Service Bulletin

SB99-71-06

ENGINE EXHAUST TAILPIPE LANYARD INSTALLATION AND FUEL FLOW TRANSDUCER RELOCATION

T206H

Figure 1. Fuel Flow Transducer Relocation. (Sheet 1 of 4)

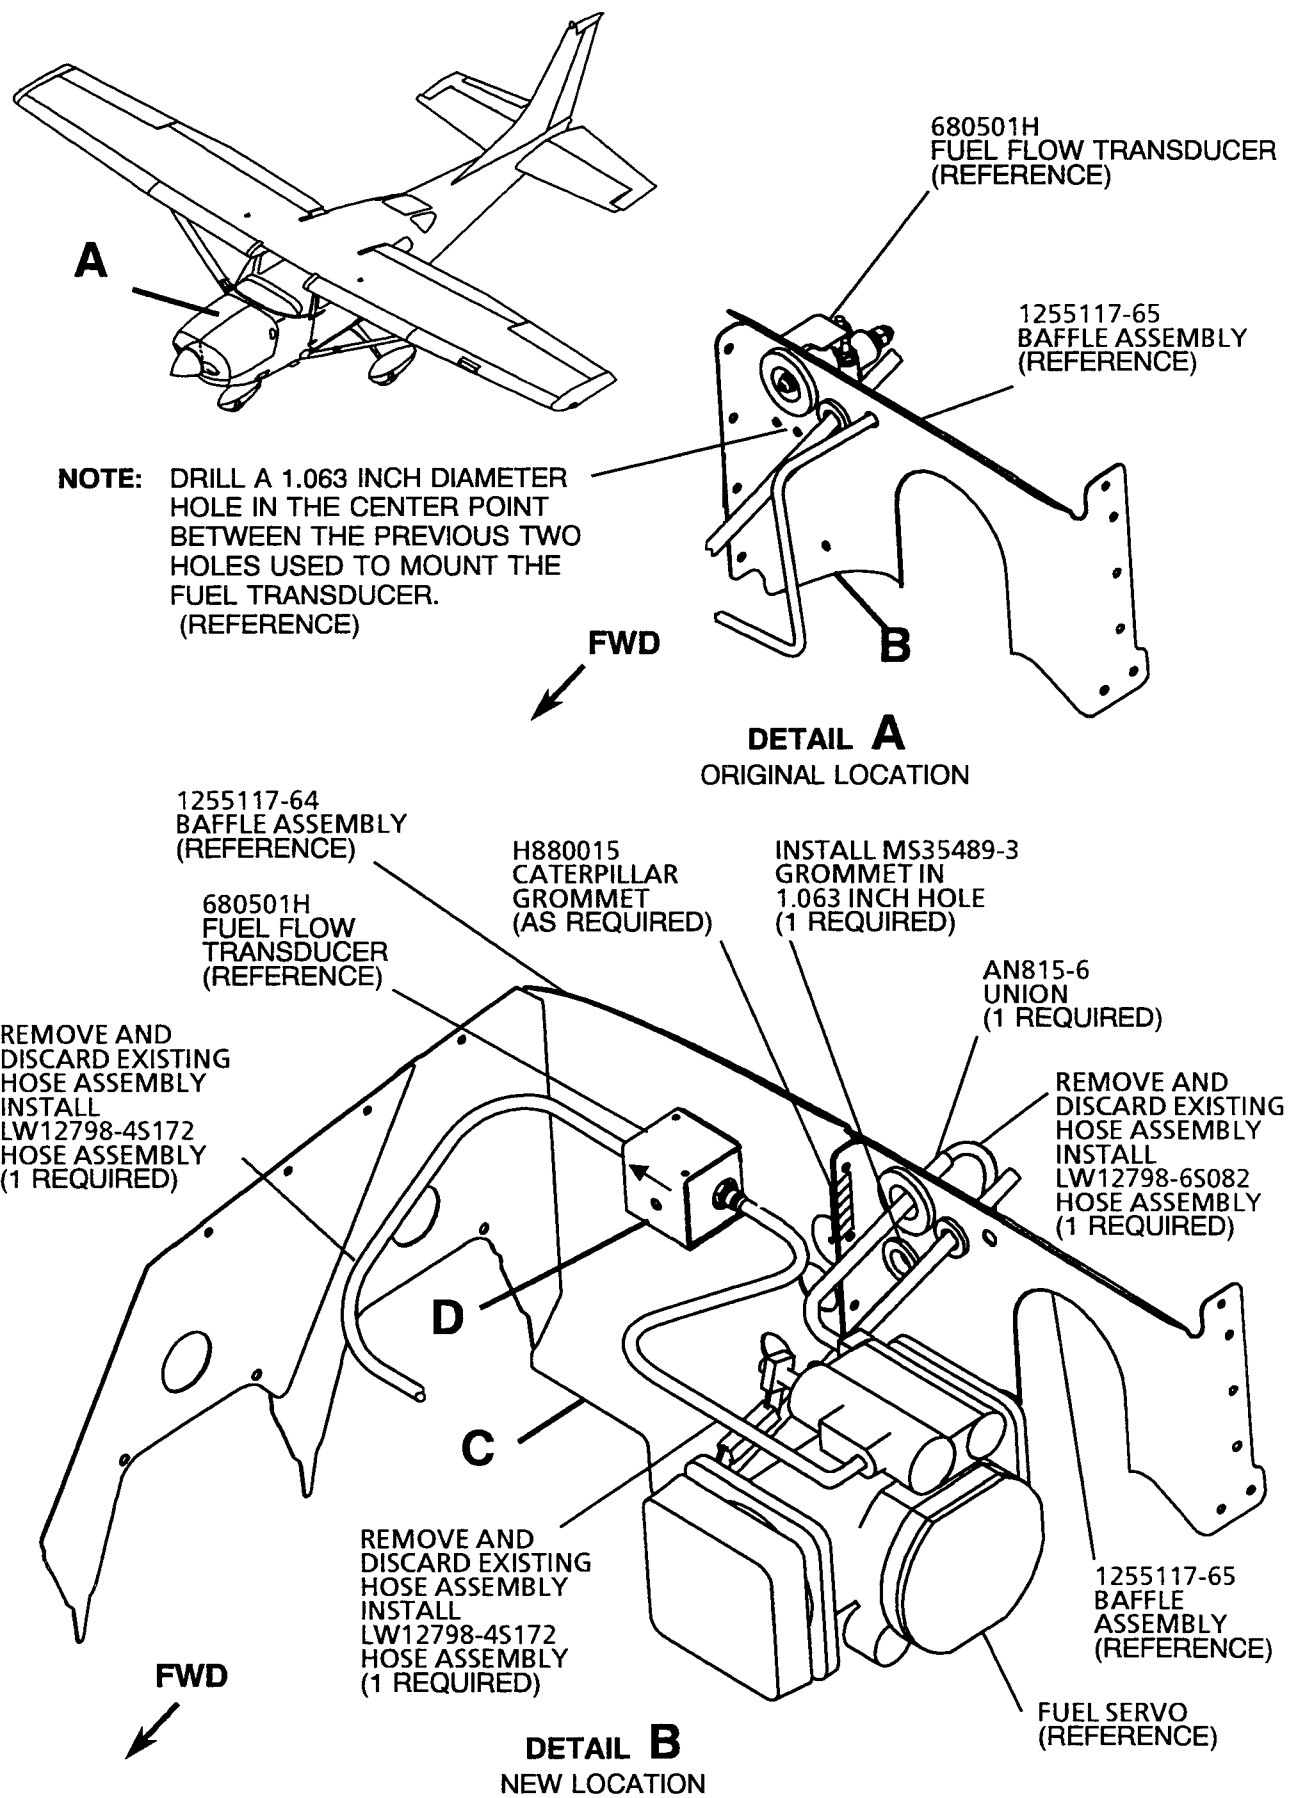
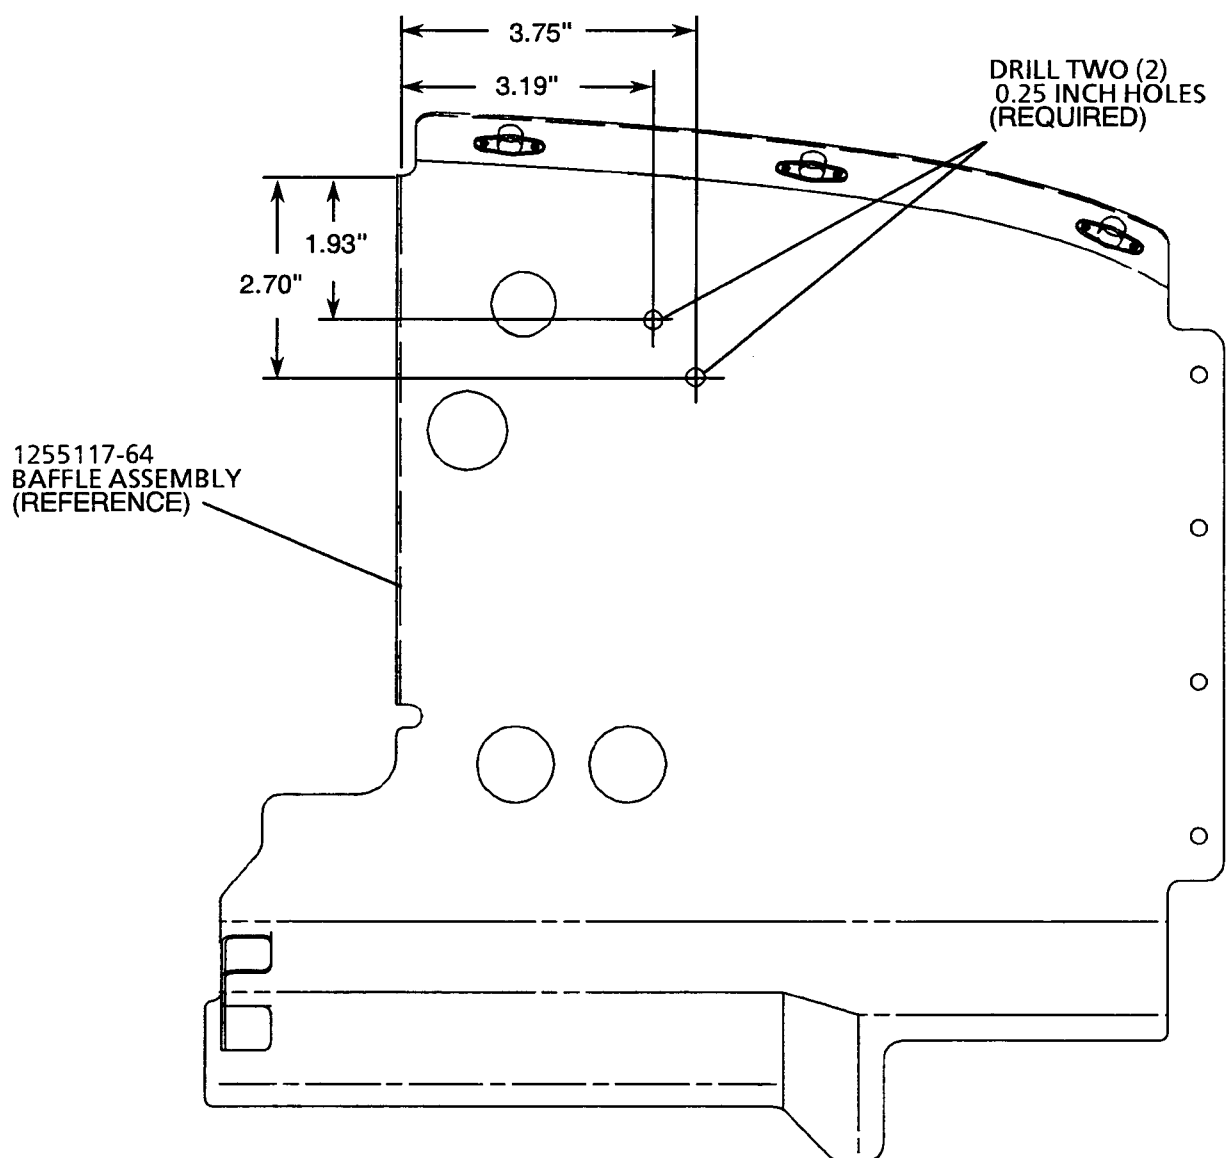
A. (Refer to Figure 1, Sheet 1, Details A and B.) Remove fuel lines and fittings:

- (1) Remove the existing LW-12879-6S060 Fuel Hose assembly that attaches to the outlet of the transducer and to the servo inlet port and discard.
- (2) Remove the LW12878-4S110 Hose Assembly that attaches the servo outlet port with the fuel flow divider valve inlet port and discard.
- (3) Remove the 90 degree MS20822-4 Fitting from the fuel flow divider valve inlet port and discard. Replace with an AN816-4 fitting.

C. (Refer to Figure 1, Sheet 1) Reinstallation of the 680501H Fuel Flow Transducer Assembly.

D. (Refer to Figure 1, Sheet 1, Detail B.) Fuel Hose Assembly Installation:

- (1) Connect and torque the LW12879-6S082 Hose Assembly between the fuel servo and the existing hose assembly attached to the fuel pump using an AN815-6 Union.
- (2) Connect and torque one (1) LW12798-4S172 Hose Assembly between the fuel servo outlet port and the fuel flow transducer inlet port.
- (3) Connect and torque one (1) LW12798-4S172 Hose Assembly between the fuel flow transducer outlet port and fuel flow divider valve inlet port.

- (2) (Refer to Figure 1, Sheet 1, Detail A, Detail B) Locate the center point between the two 0.193 inch diameter holes previously used to mount the 1255117-48 Transducer Bracket. Drill a 1.063 inch diameter hole in this location.

- (3) (Refer to Figure 1, Sheet 1, Detail B.) Split half of a MS35489-3 Grommet and install in the 1.063 inch diameter hole.
- (4) Route the transducer power mating connector through the 1.063 inch diameter hole drilled in step 4.E.(2), and mate with transducer connector. Secure with S1781-2 Sta-Straps as required.

- (5) Install S2562-1 Convoluted Tubing as required aft of the baffle to protect exposed wire and splices.
- (6) (Refer to Figure 1, Sheet 1, Detail B.) Install a 1.5 inch piece of H880015 Nylon Caterpillar Grommet with EC1300LP Adhesive, positioned to prevent chafing of the fuel line against the flanges where the 1255117-64 Baffle and the 1255117-64 Baffle are fastened together.

Figure 1. Fuel Flow Transducer Relocation. (Sheet 2)

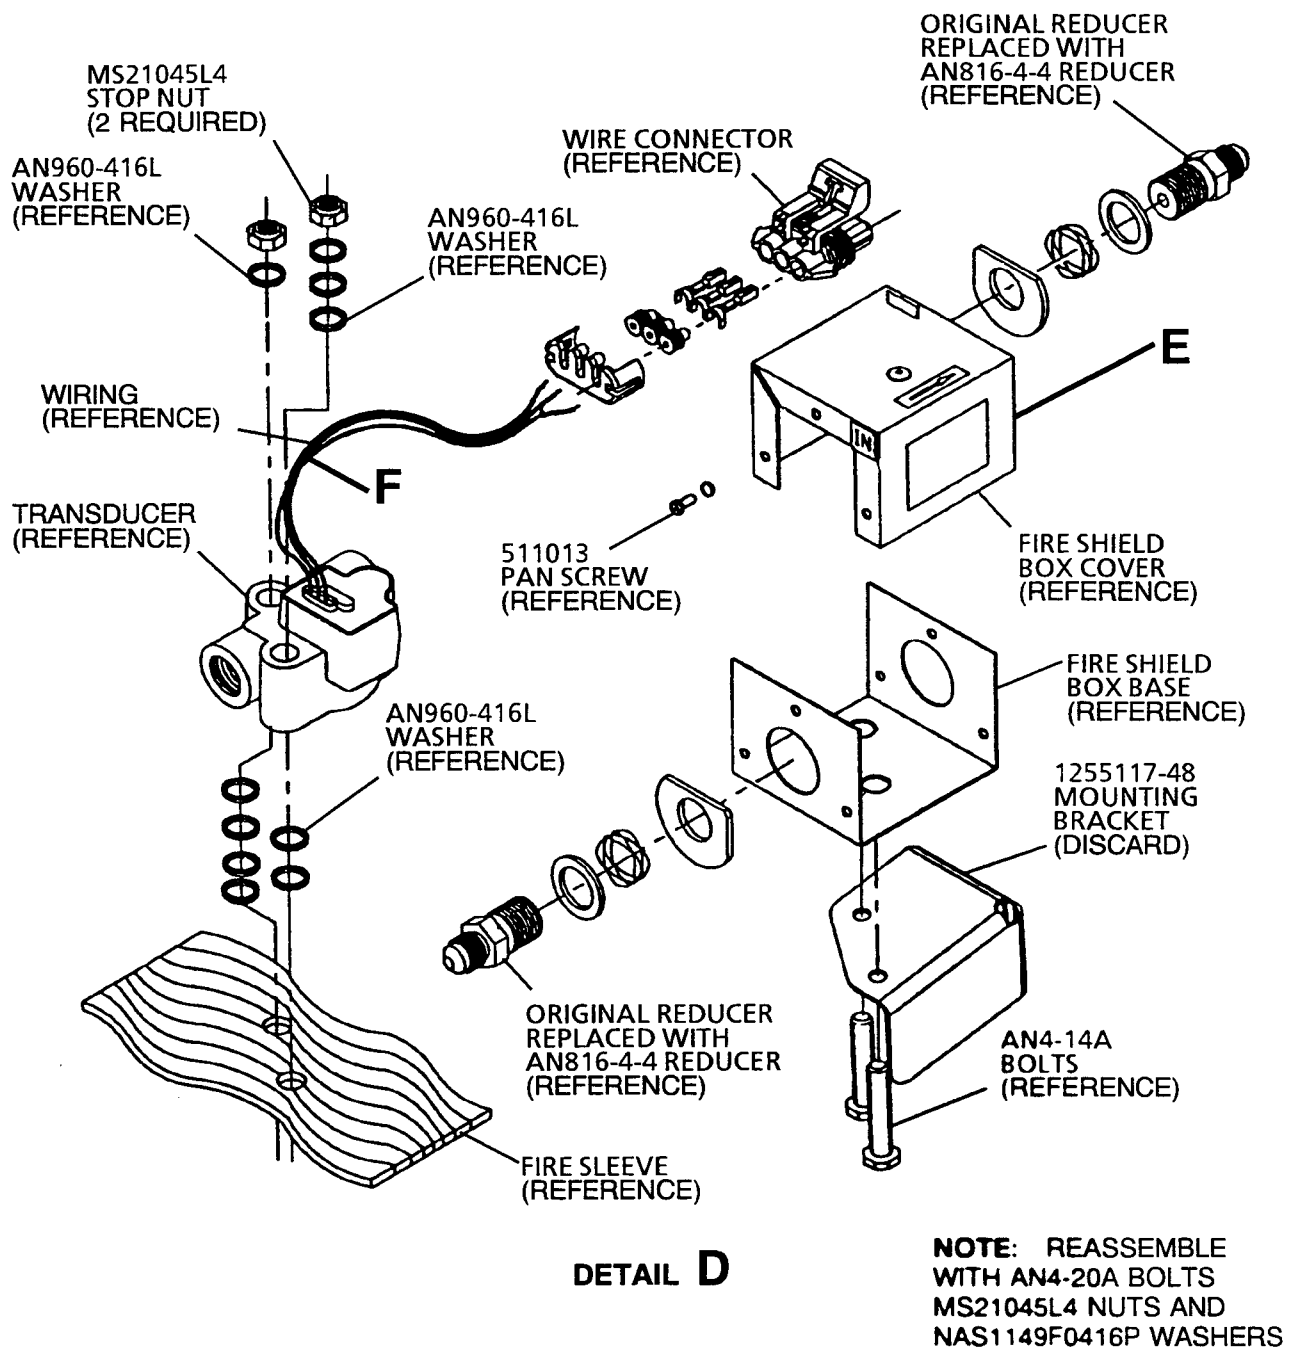
- (1) (Refer to Figure 1, Sheet 2) Drill two additional 0.25 inch diameter holes in the 1255117-64 Baffle Assembly.
- (2) (Refer to Figure 1, Sheet 3, Detail D, and Sheet 4, Detail E.) Position the fuel flow transducer assembly with the fuel flow arrow pointing outboard at the forward side of the 1255117-64 Baffle Assembly at the two 0.25 inch holes drilled in step 4.C.(1).
 - (a) Use two (2) NAS43HT4-32 Spacers between the bottom of the transducer fire shield box base and the 1255117-64 Baffle Assembly.
 - (b) Install the transducer fire shield box base to the 1255117-64 Baffle Assembly using two (2) AN4-20A Bolts, two (2) MS21045-L4 Nuts and two (2) NAS1149F0416P Washers.

Figure 1. Fuel Flow Transducer Relocation. (Sheet 3)

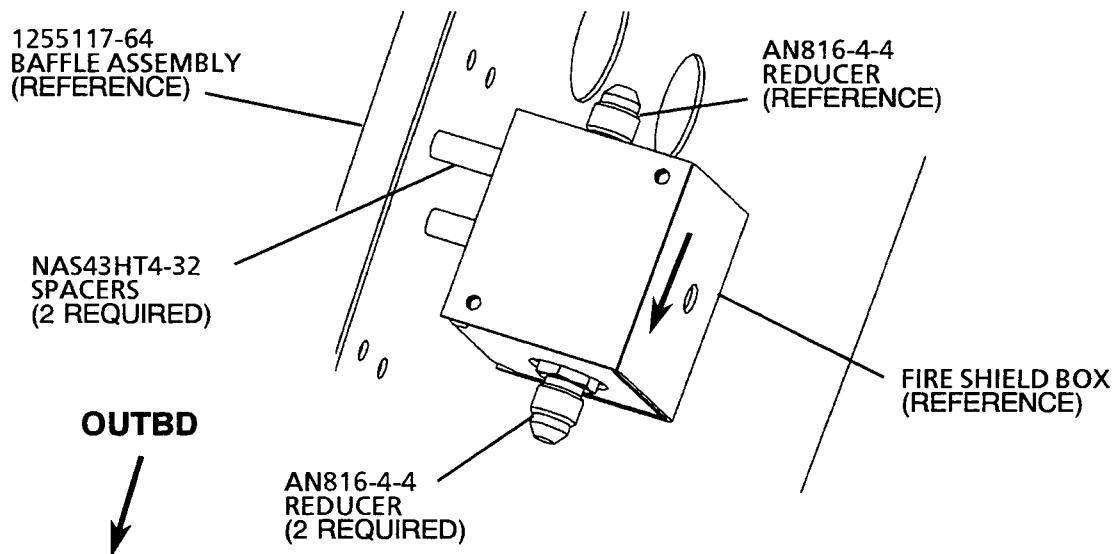
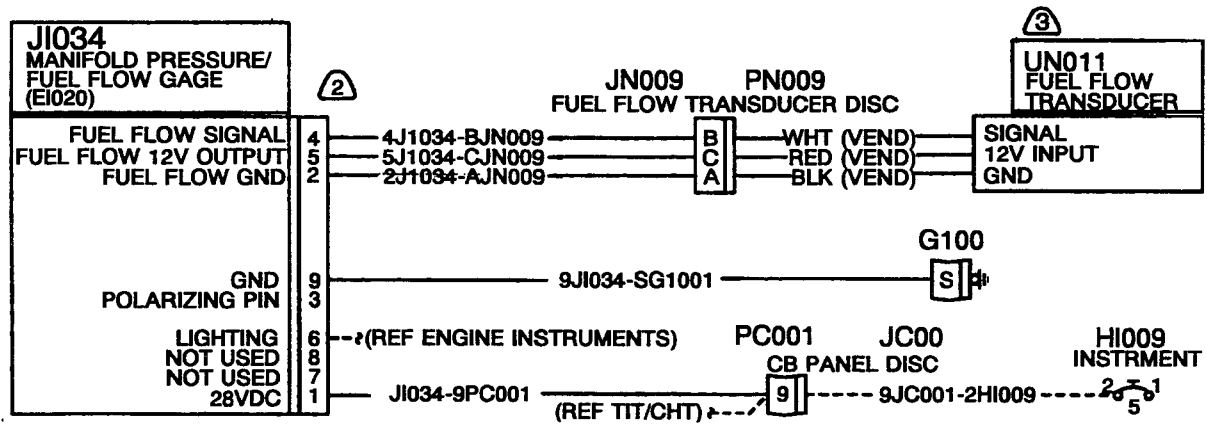
B. (Refer to Figure 1, Sheet 3, Detail D.) Removal and disassembly of the 680501H Fuel Flow Transducer Assembly:

- (1) Disconnect the wire connector from the transducer assembly.
- (2) Remove the 680501H Fuel Flow Transducer assembly from the 1255117-64 Baffle Assembly by removing the two (2) mounting screws. Discard the mounting screws.
- (3) Remove and retain the 610504 Fire Shield Box Cover. Retain the six (6) pan screws for reinstallation.
- (4) Remove and discard the existing 1255117-48 Mounting Bracket and the attaching hardware from the back of the transducer.
- (5) Remove and discard the existing inlet and outlet reducers. Install two (2) AN816-4-4 Adapters.

E. (Refer to Figure 1, Sheet 3, Detail D and Sheet 4, Detail F.) Wire Modification:

- (1) If sufficient wire length from the fuel flow gauge is not available for the new transducer location, splice and increase the wire length near the transducer mating connector using S2589-22-9 wire as required, and M81824/1-1 Splices. Ensure each wire of the three wire group from the fuel flow gauge is spliced with the correct plug pin wire.

Figure 1. Fuel Flow Transducer Relocation. (Sheet 4)

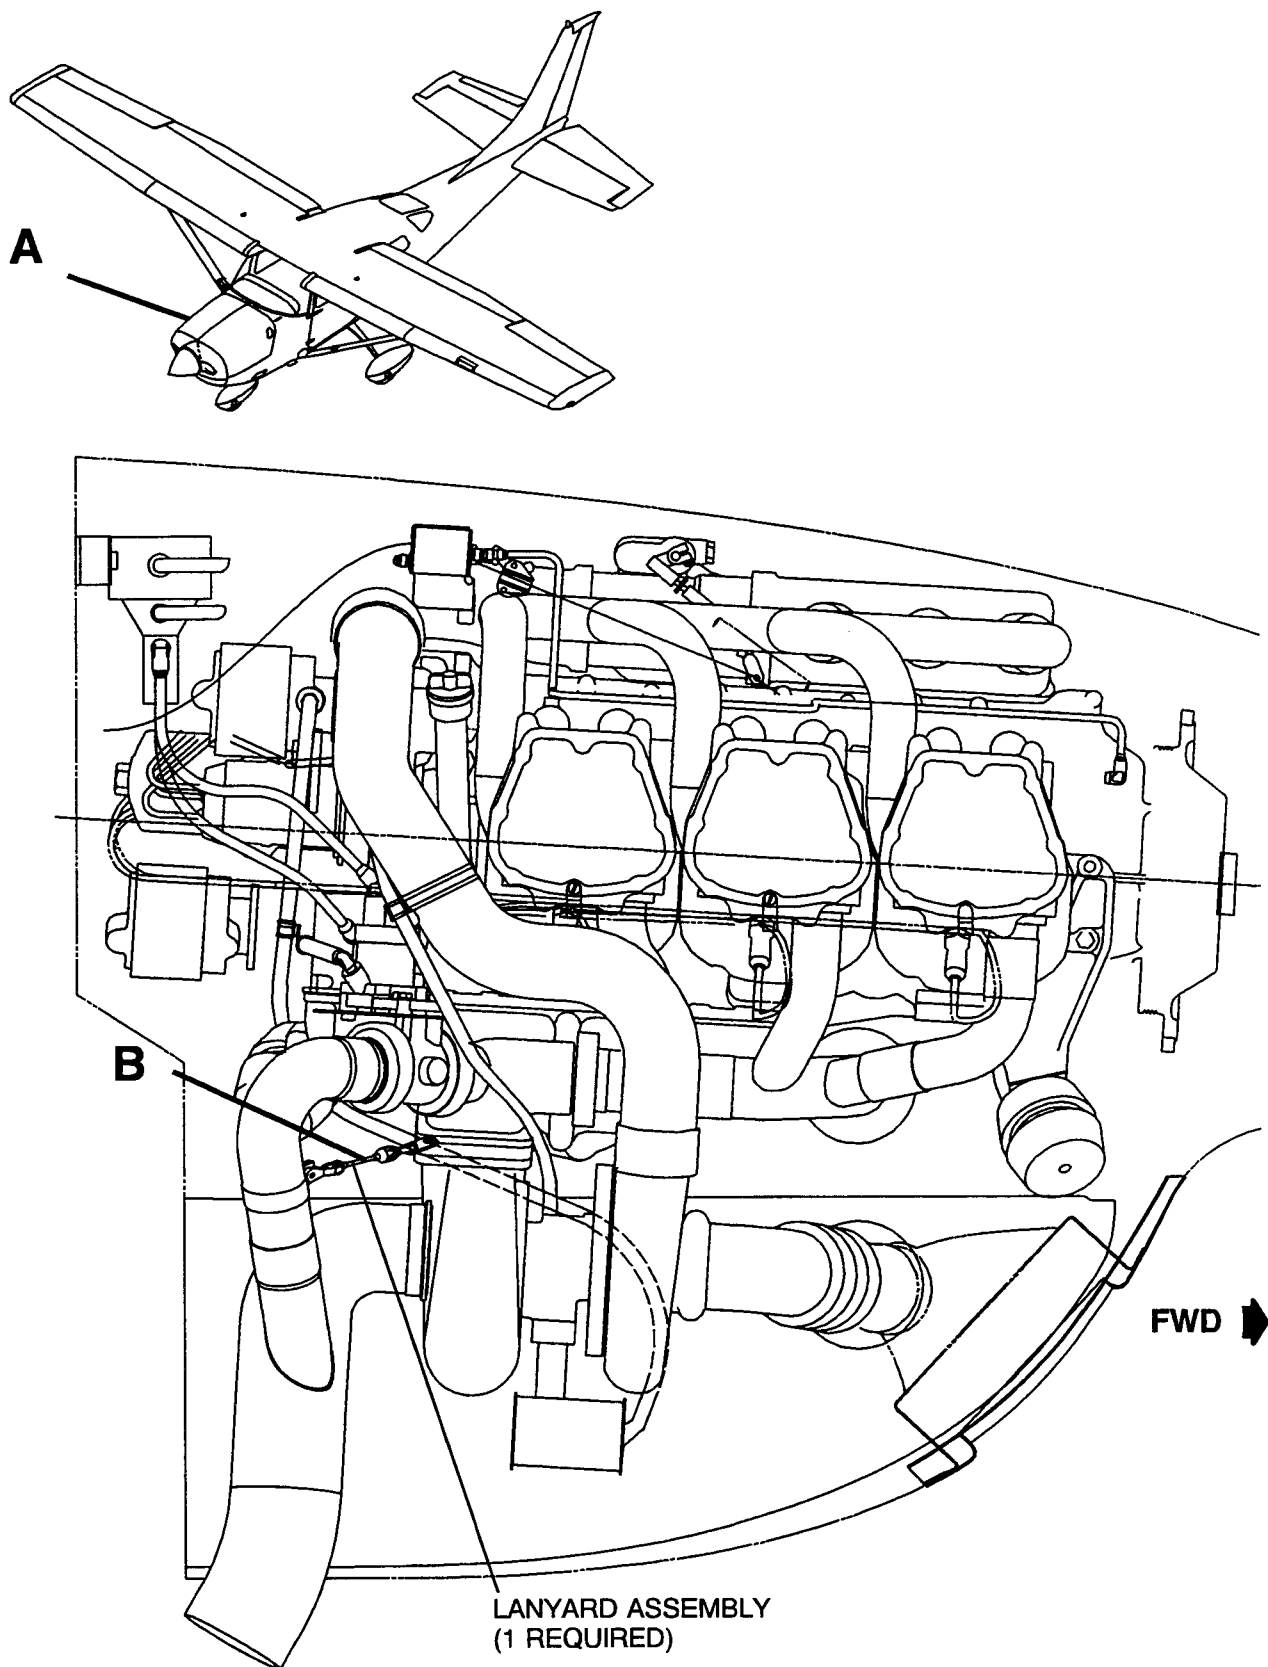
NOTE: It is permissible to add AN960-416L Washers as required, above and below the transducer and the transducer fire shield box cover and base, to align the AN816-4-4 Reducers with the center of the holes in the transducer's fire shield box base.
